# Report to Congress on the Structural Assessment of the New U.S. Embassy Office Building in Moscow

April 15, 1987

**NBSIR 87-3636**

Figure 11 PARTITION PLAN OF CORE (Floors 2-7)

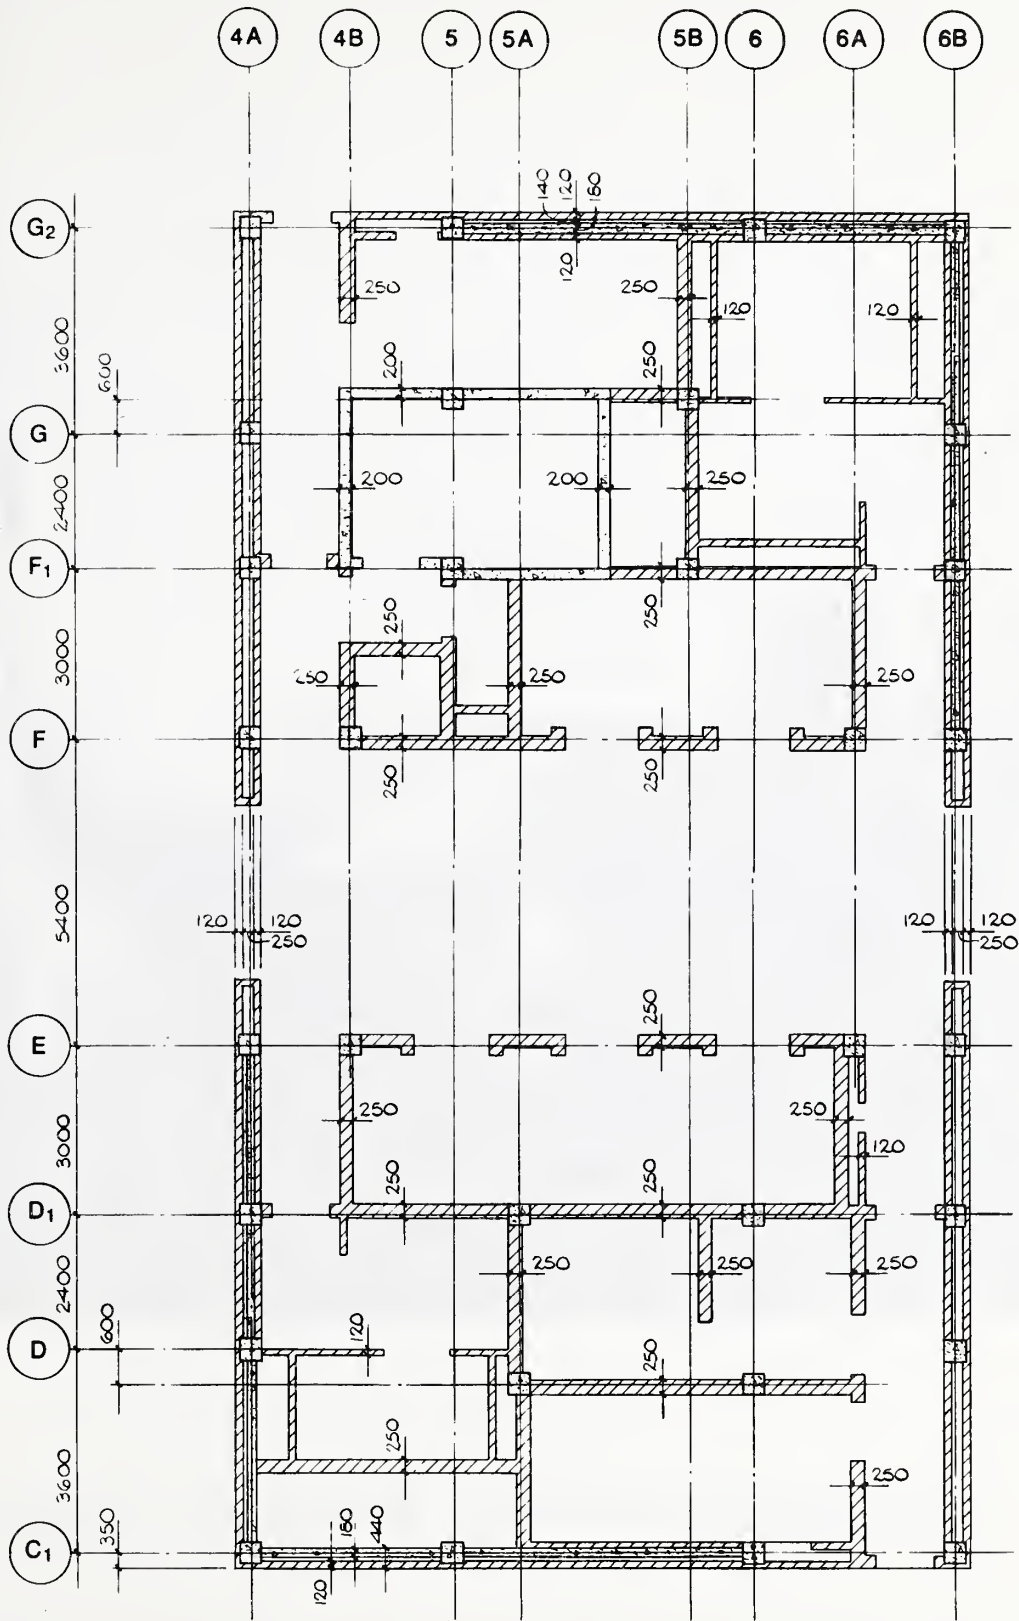
Inspection of the brick partitions in the core area revealed that many of these walls are either unfinished or otherwise incomplete at the top so that they are not tightly built in with the building structure. Wall specimens and individual Soviet-produced bricks were brought back to the NBS laboratories for testing to provide physical property information needed for analyzing the as-built construction.

Consideration of the potential for progressive collapse showed that alternate load paths are not presently available in the event of the failure of some columns in the core area of the building. Gaps between masonry walls and adjacent beams and columns should be filled and the walls strengthened to provide the needed alternate load paths. The estimated cost is \$263,000.

Figure 14 NBS TEST OF COLUMN JOINT

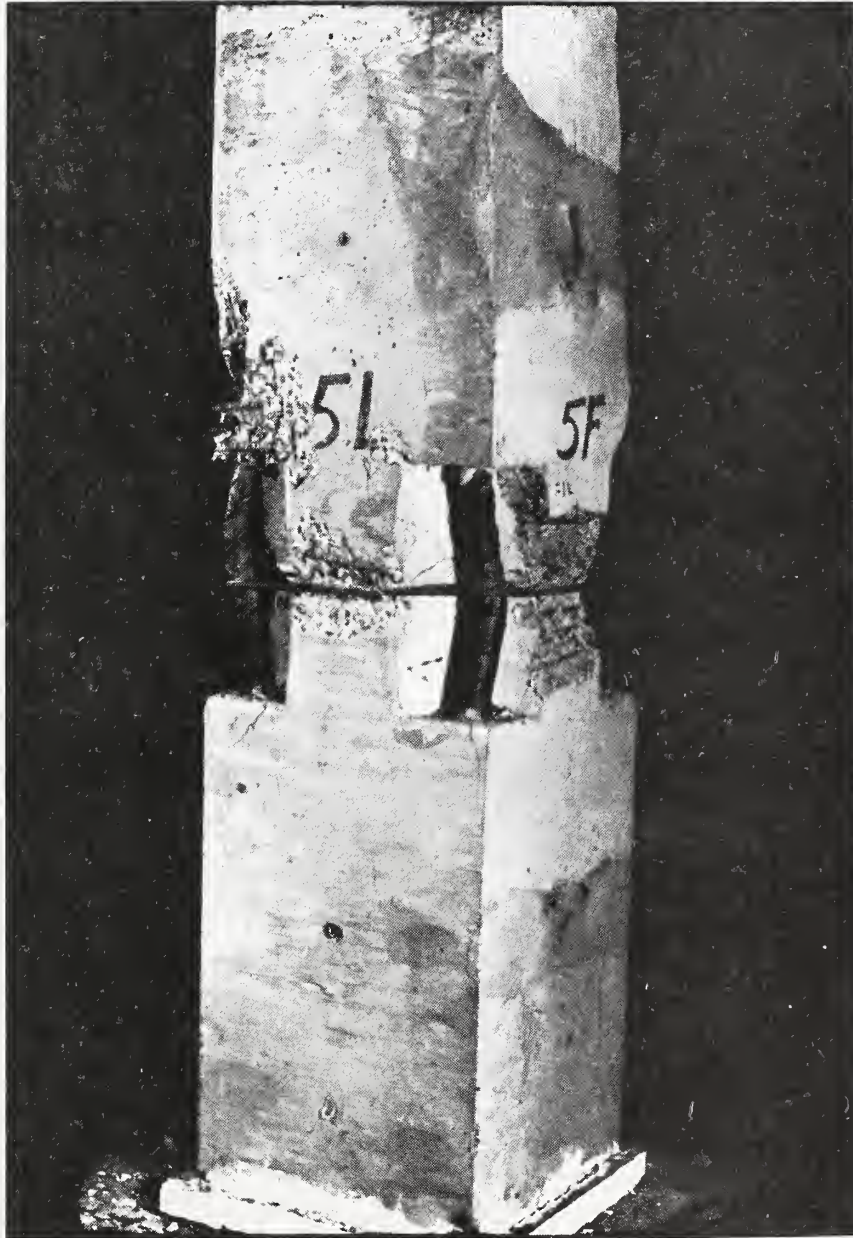
segment. Laboratory tests at NBS on facsimilies of complete and incomplete joints, figure 14, show that strength is degraded as much as 56 percent by incompletely grouted and concreted joints. Deficiencies also were found in completion of the vertical joints, figure 15, and horizontal joints, figure 16, between shear wall panels. Few of the shear wall joints investigated were properly grouted and concreted. The bond between the topping and the floor planks was assessed by sounding and coring at a number of locations. In no core sample was the topping soundly bonded to the floor plank.

Site investigation showed that the integrity of all joints of reinforced concrete columns is questionable. Laboratory studies showed that failure to place grout and concrete in the joint severely reduces the column strength. Each such joint should be exposed and drilled to determine whether the joint area is filled with grout and concrete, and each deficient joint should be filled. The estimated cost for this remedial measure is \$132,000.

Figure 17 CRACKS ON SOUTH ELEVATION

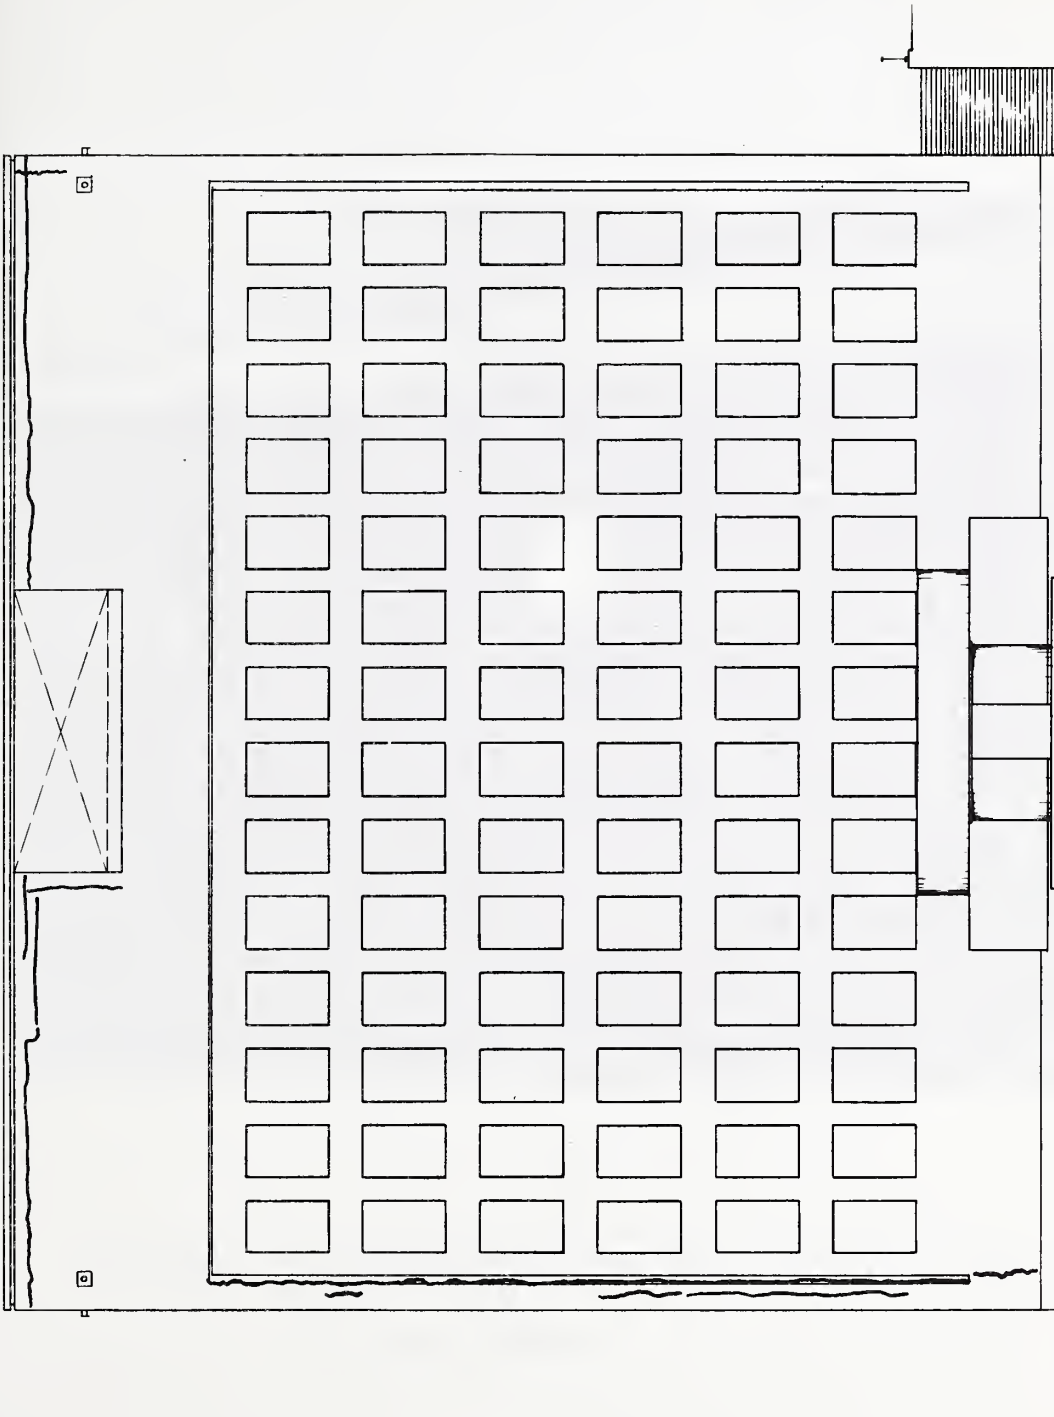
A detailed visual examination of the exterior brick masonry walls was performed from ground level and by descending the building (see cover photograph). The exterior walls showed vertical cracking on all four sides of the building. An example is shown in figure 17. Vertical cracks on two of the corners run from ground elevation to the top of the seventh story. Vertical cracks were seen in five piers between windows at the second story columns. The most severe horizontal cracking occurs in the parapet walls, all of which have horizontal cracks either on the inside, the outside, or on both sides. An example is shown in figure 18. Vertical cracks also were noted in the parapet walls. The penthouse walls show both horizontal and vertical cracks, but they are fewer in number and smaller in size than the parapet cracks.

Site investigation showed substantial cracking in the exterior masonry walls. Vertical expansion joints should be provided in the corner piers to allow for differential movement and sealed to prevent entrance of moisture. The estimated cost for this remedial measure is \$22,000.

The site investigation showed vertical cracks in the masonry walls. The scope of this investigation did not permit a definitive determination of their cause. They may result from excessive vertical compressive stress leading to vertical splitting. A program should be conducted for long-term monitoring of these cracks to determine whether they are growing in extent or number. From these observations and further analyses, appropriate remedial measures can be formulated, if required. For a two-year program, the estimated cost is \$200,000.
